Addendum #1

Frink Centre

Hi-Lo Boardwalk - Design and Construction

Addendum #1

Frink - Hi-Lo Boardwalk

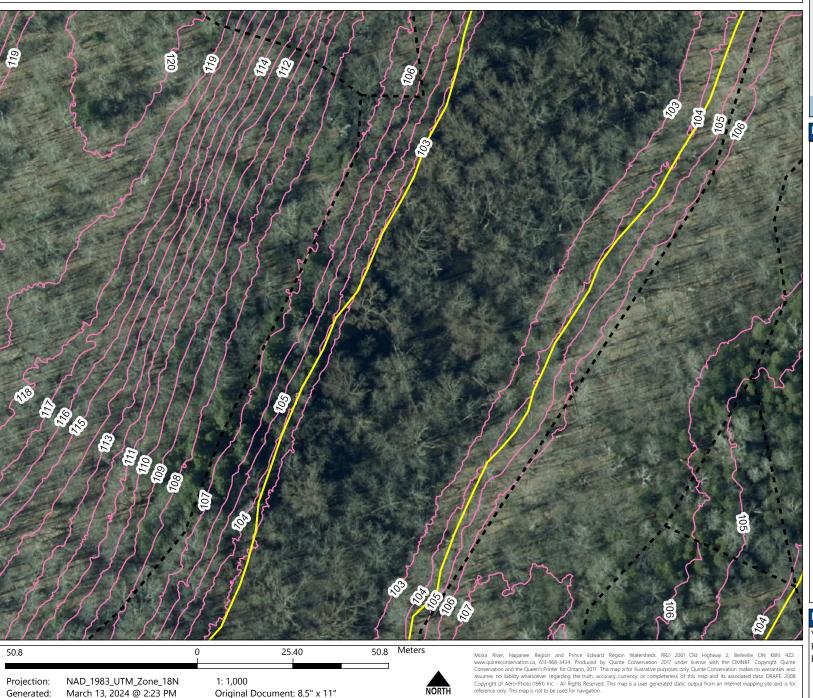
- 7. The planks of the boardwalk shall be 5'.
- 8. Lidar places the bottom of the ravine at approx. 103m (CGVD2013) (See the below attachement) Quinte Conservation is engaging an OLS to provide a local benchmark and more accurate elevation to assist in tender preparation. The contractor is responsible for verifying all elevations are accurate. The elevation information will be distributed via addendum when it becomes available.
